Contract No. T201280102.02
STATEWIDE HOPPER RACKS
Statewide

Enclosed is Addendum No. 2 for the referenced contract consisting of the following:

Delaware Department of Transportation
QUESTIONS AND ANSWERS
T201280102.02
STATEWIDE HOPPER RACKS
Thursday, March 14, 2013

P2
S101
TYPICAL ROOF FRAMING PLAN
1/4" = 1'-0"

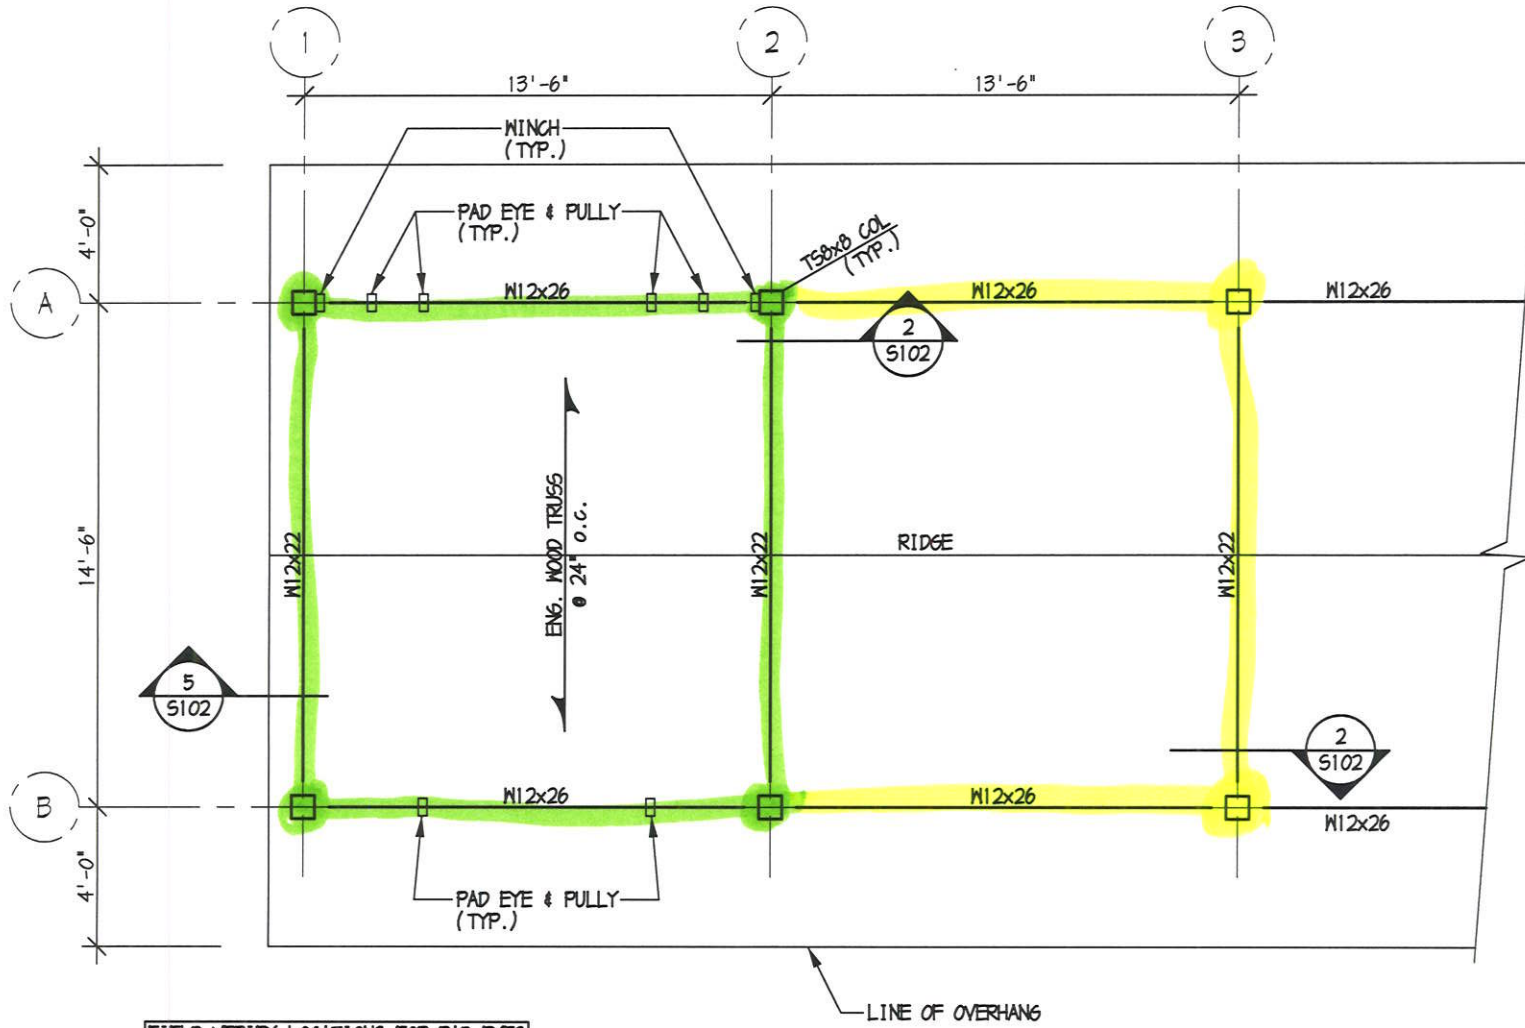
Q #	Question	Answer
4	Locations 4 and 5 of Breakout Sheet 1 refer to "Base Hopper Rack Bay" and "C shaped Add on to Base Bay". Please provide definitions for each on these items and what is to be included in each of them.	<p>Location 4 is intended to be the unit price for one square bay, to be used as the price for the first hopper bay in a row at any add-on locations. This includes the footings and steel but no site work (outside the actual construction of the posts) or roof systems (except holes drilled for future roof systems, like Magnolia).</p> <p>Location 5 is for each subsequent bay connected to a location 4 bay at the particular add-on location. Because the "base" unit would already be included (as "location 4"), only three sides would essentially be needed (which is why the term "C" shaped was used in the specifications). Again this includes the footings and steel but no site work (outside the actual construction of the posts) or roof systems (except holes drilled for future roof systems, like Magnolia). Please note, we must have a location 4 bay first before we can add additional location 5 bays. There is however no limit to how many location 5 bays that can be added to any given location 4 bay. This was also described on page 9 of the pre-bid transcript.</p>

Location 4
Location 5
